Proposal #03: 1400-01-70, WISC 2022 002
Portage - Columbus
Lincoln to Fall River-Columbus Rd
STH 16
Columbia County

1400-01-73, WISC 2022 003
Portage - Columbus
USH 51 to Lincoln Ave
STH 16
Columbia County

This is Addendum No. 02, which provides for the following:

Addendum No. 01
ID 1400-01-70
Revised Sheet 249
November 4, 2021

CROSS SECTION & QUANTITIES
SHEET 2
249

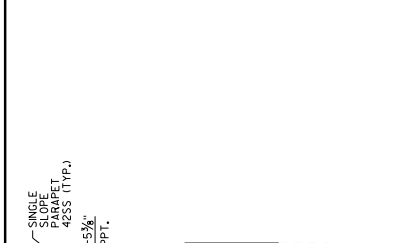
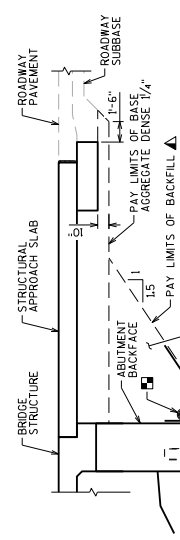
Revised Plan Sheets – 1400-01-70	
Plan Sheet	Plan Sheet Title (brief description of changes to sheet)
249	Structure Plan – Revised quantity for bid item 550.0020

NO.	DATE	REVISION	BY
11/21		REVISE PRE-BORING QUANTITY	CSP
			11/04/21

516.0500	RUBBERIZED MEMBRANE WATERPROOFING	SY		12	12	12	12	12		24
550.0020	PRE-BORING ROCK OR CONSOLIDATED MATERIALS	LF			90	10	90			200
550.0500	PILE POINTS	EACH								14
